1. CALL TO ORDER
2. ROLL CALL
3. APPROVAL OF AGENDA
4. PUBLIC HEARINGS
 - A. **SPECIAL LAND USE – TORTILLA TITA – 585 JOE HALL DRIVE – PARCEL K-11-17-363-029 – TO CONSIDER THE SPECIAL LAND USE REQUEST OF FRANCISCO ALVAREZ/MARTHA JARAMILLO TO PERMIT THE CONSTRUCTION OF A 6,000 SQUARE FOOT TWO-STORY FOOD PROCESSING FACILITY ON A 1.093 – ACRE SITE ZONED I-T, INNOVATION AND TECHNOLOGY**

Project Name: Tortilla Tita - Food Processing Building

Staff Report
Tortillas Tita: Food Processing Building
585 Joe Hall Drive, Ypsilanti, MI 48197
Preliminary Site Plan & Special Land Use

RE: Tita Tortillas
Preliminary Site Plan Review #3

SHEET NUMBER
C-6

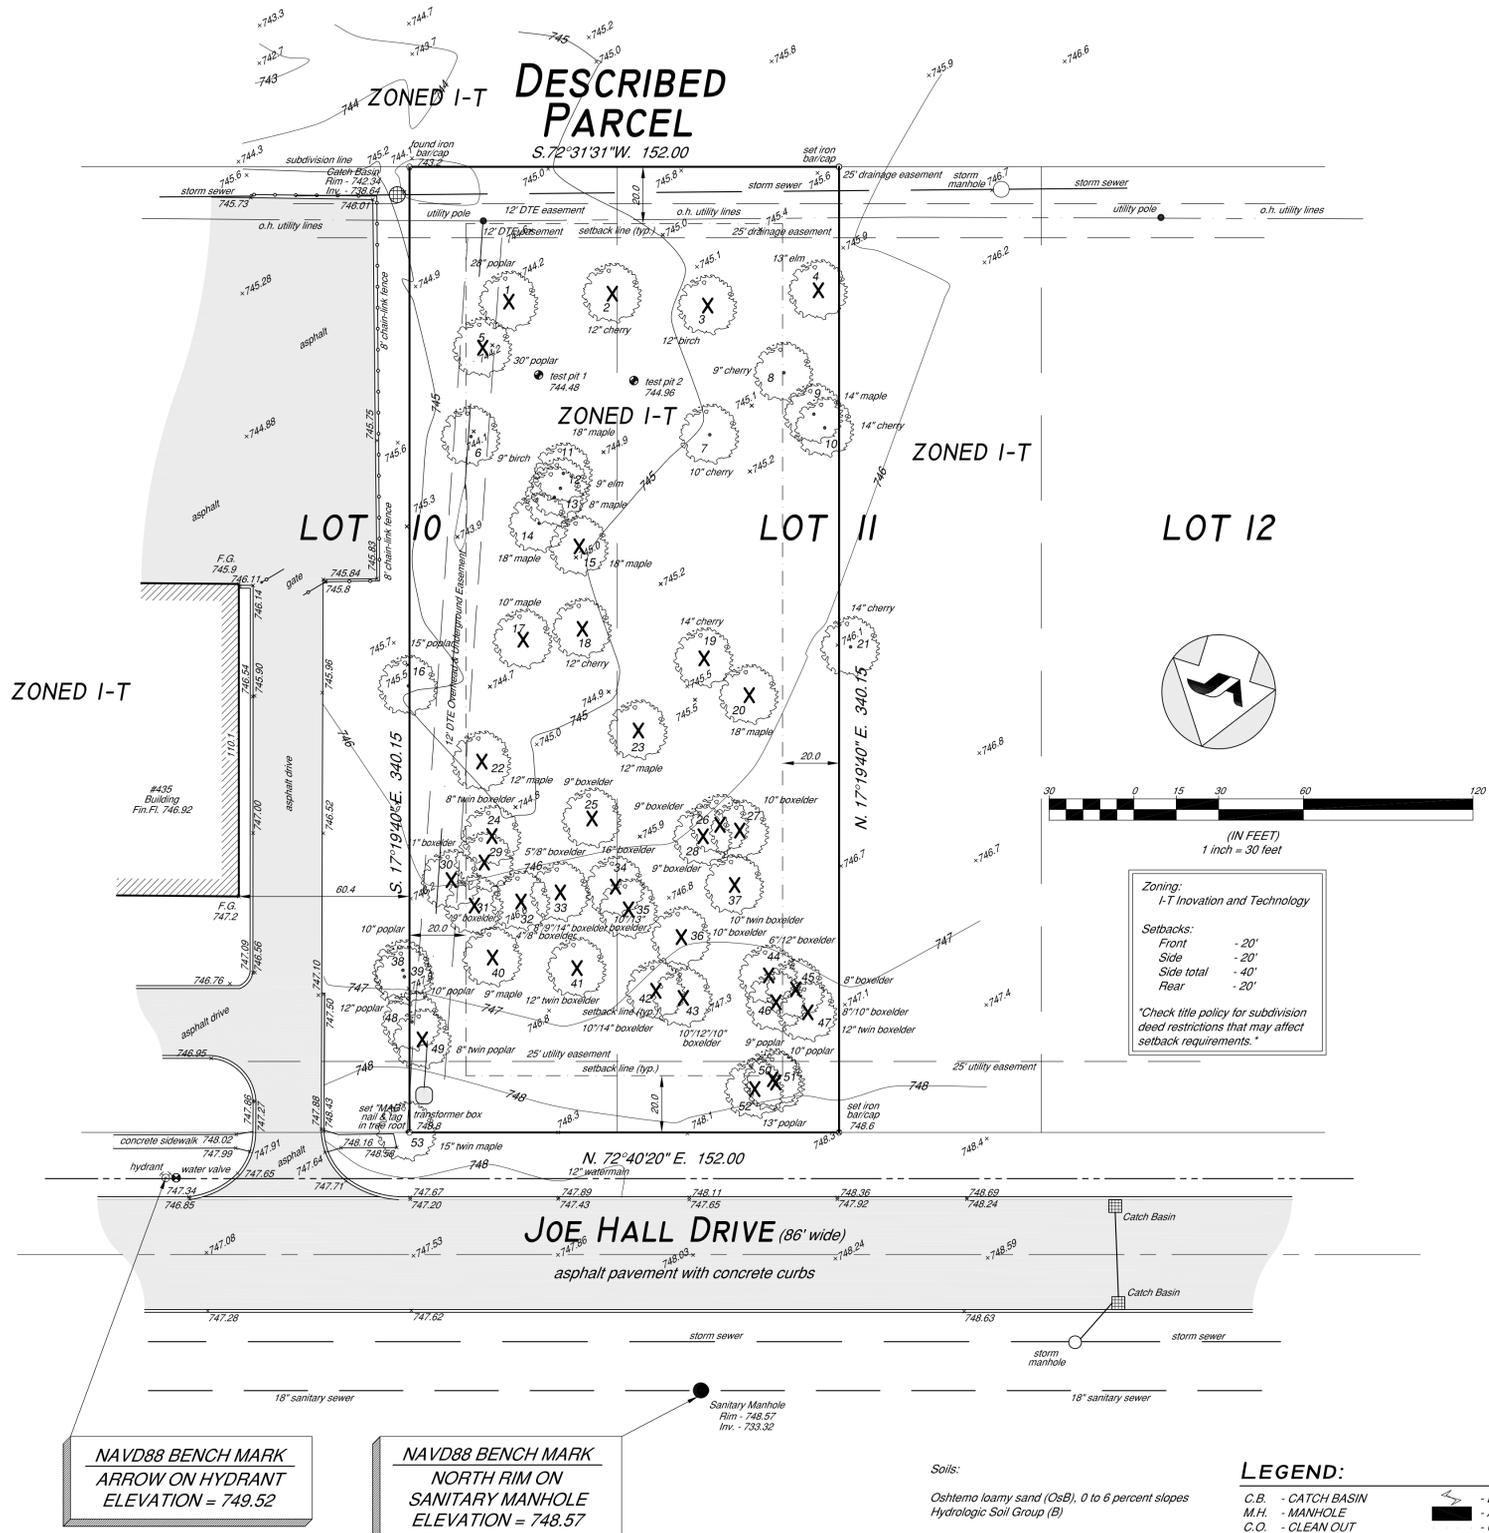
Woodlands: The site is wooded. The applicant has provided a tree survey, as required in Chapter 24, Article III – Woodlands Protection, showing the location of existing trees on Sheet C-6. A tree inventory table has also been provided. We have the following comments regarding tree removal:

- Sec. 24-68, *Relocation or Replacement* requires that removed trees shall be replaced on a one-to-one ratio. At this time, this project would be required to plant 38 new trees, that are a minimum of 2.0” in caliper. The ordinance does not allow landscaping trees to also count as replacement trees. However, Sec. 24-67, *Review Standards*, gives the Planning Commission the ability to reduce the number of replacement trees to no less than 30% of the required number for industrial properties in instances where 100% tree replacement is not feasible. If the Planning Commission approved the maximum reduction, then 27 replacement trees would be required on this site, in addition to trees required to meet landscaping requirements. Also, the Planning Commission may allow replacement trees to be planted on other approved property, or the applicant may pay into the Township Tree Fund, based on the number of replacement trees determined by the Planning Commission. The applicant’s response letter states that replacement trees will be planted off site, or a contribution will be made to the township’s tree fund. The applicant needs to clarify:

- a. Where will replacement trees be planted? If this option is chosen, the Planning Commission will need to approve the location.

- b. If a contribution is made, we recommend that the Planning Commission condition any Preliminary Site Plan approval on the Township reviewing and approving the calculations to determine the tree fund contribution amount, based on typical fees charged by a landscape contractor to purchase, deliver, and install a 2.0-inch caliper tree at Final Site Plan approval.
- As requested:
 - a. Tree protection fencing has been added to Trees #21, #38, and #39. These trees are on adjacent properties near the site.
 - b. Tree protection fencing has also been added for Trees #9, #10, #16, and #53 in addition to the other trees within the project site.

Soils: Sheet C-6 states that the soils on this property are Oshtemo loamy sand, 0-6% slopes.

Items to be addressed: 1) Planning Commission and applicant to discuss tree replacement options. a. If planting on another site is chosen, Planning Commission to approve chosen site. b. If payment in-lieu-of planting replacement trees is chosen, recommend conditioning any Preliminary Site Plan approval on the Township reviewing and approving the calculations to determine the tree fund contribution amount, based on typical fees charged by a landscape contractor to purchase, deliver, and install a 2.0-inch caliper tree, at Final Site Plan approval.

C5.0
 OHM JOB NO: 0098-99-0183
 ALNM Project # 230764.00

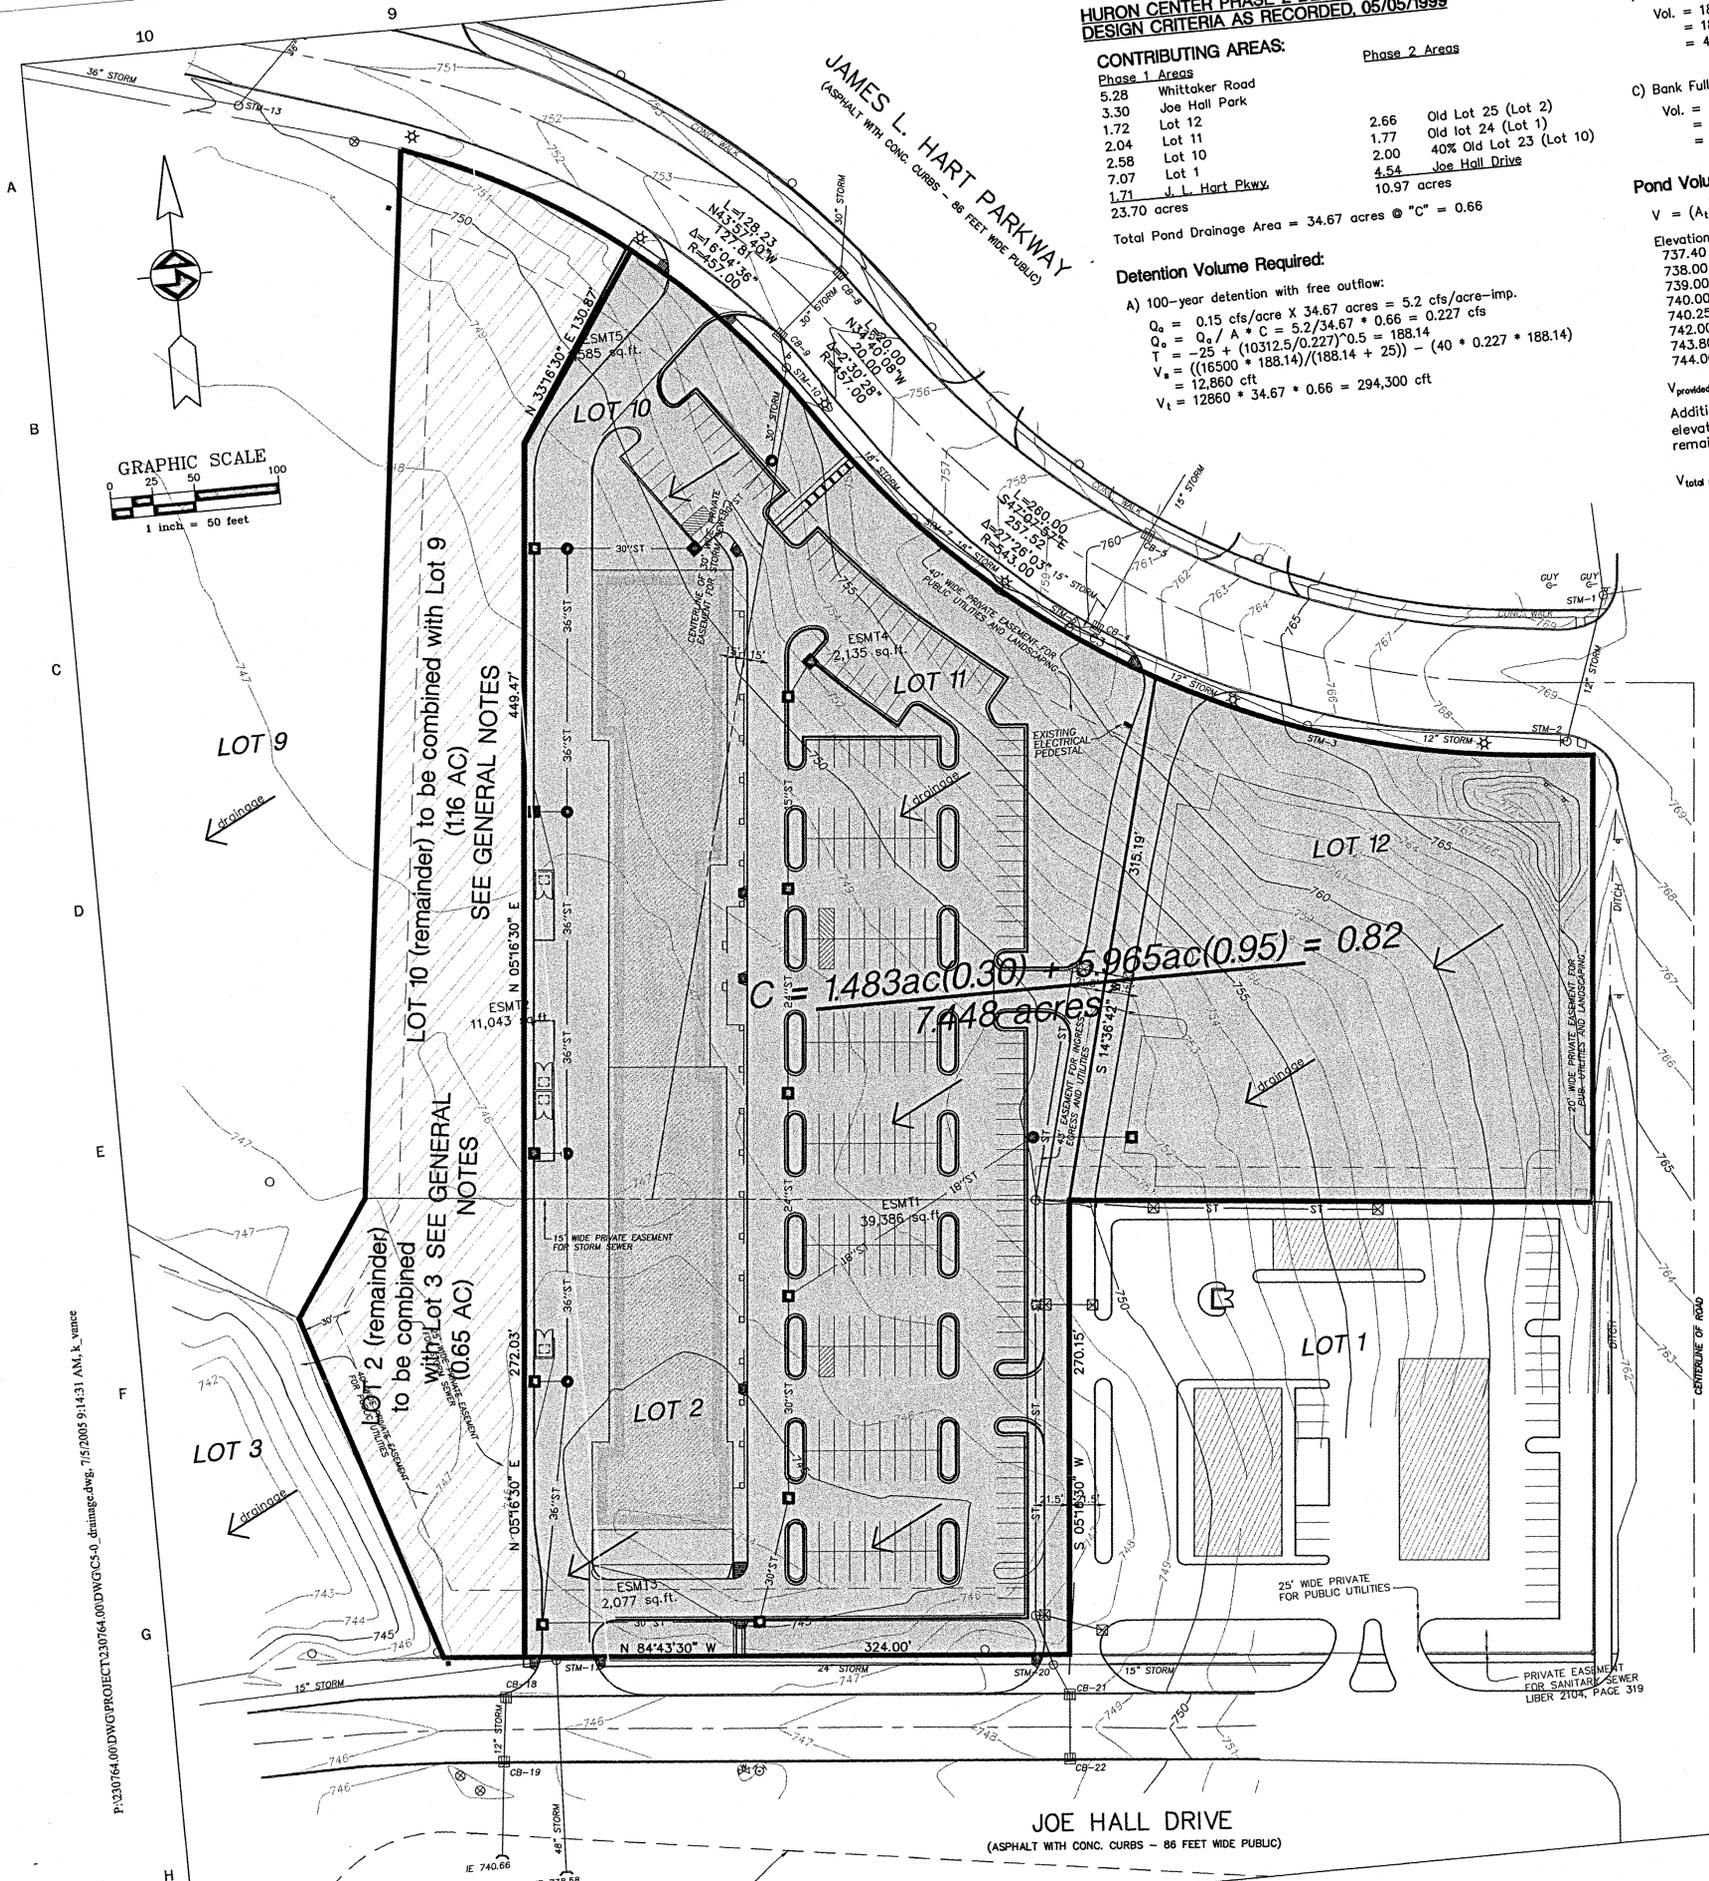
12. The proposed site is noted to be comprised of the western 73.5 feet of Lot 10 and the eastern 66.5 feet of Lot 11 from Phase II of the Huron Center Commercial and Industrial Park development. As noted on plan sheet C-5.1 dated July 26, 2005 and prepared by Ayres, Lewis, Norris, and May, Inc., the 100-year runoff from Lot 10 was accommodated in the detention basin, while the 100-year runoff from Lot 11 was to be detained on-site.

- a. The runoff calculations presented on plan sheet C-5, following the May 15, 2000 rules, use an area for Lot 10 of 1.061 acres to determine how much volume was allotted to Lot 10 within the existing detention basin. The portion of Lot 10 included in the current site appears to be much less than 1.061 acres. Provide area calculations to confirm the site area that was originally part of Lot 10.

13. The runoff calculations presented on plan sheet C-5 indicate that 9,000 cubic feet of volume is available in the existing detention basin. That volume was then listed on Worksheet W11 on “Sheet 2 of 2” within the plan set. W11 is used to determine the runoff volume credit for infiltration. The volume available in the existing basin cannot be listed on W11.
